CONDIT 66 K.V. REVISION
FROM POLE #1 TO #9

NORTHWESTERN ELECTRIC COMPANY.
PORTLAND, OREGON.

PNA-1981

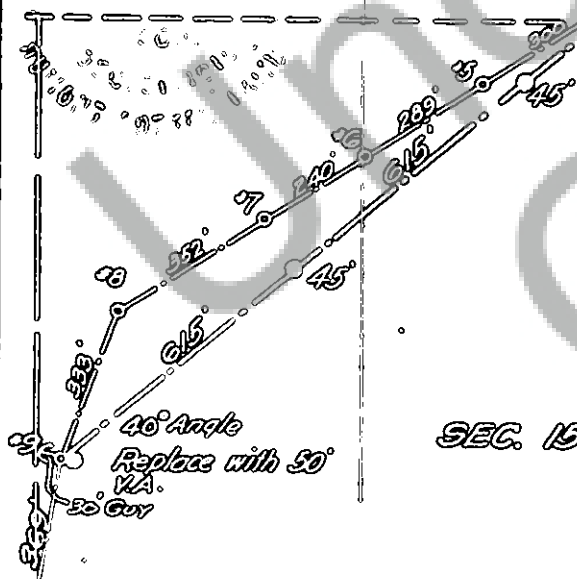
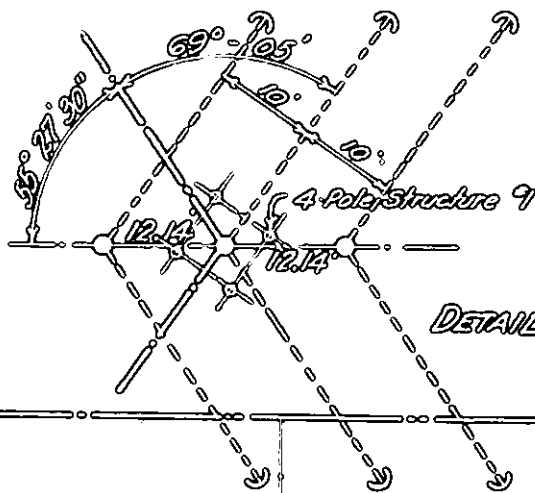
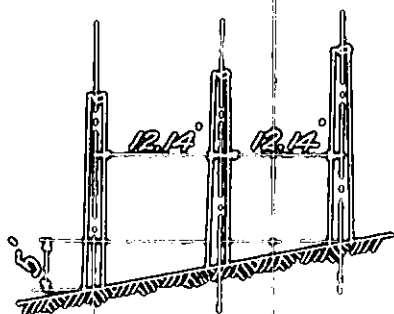
Replace #1 - (4 Pole Structure) with 3-Pole Structure

Angle 7-45

Replace with 2-40, 7' centers (Stakes are set on 10' centers)
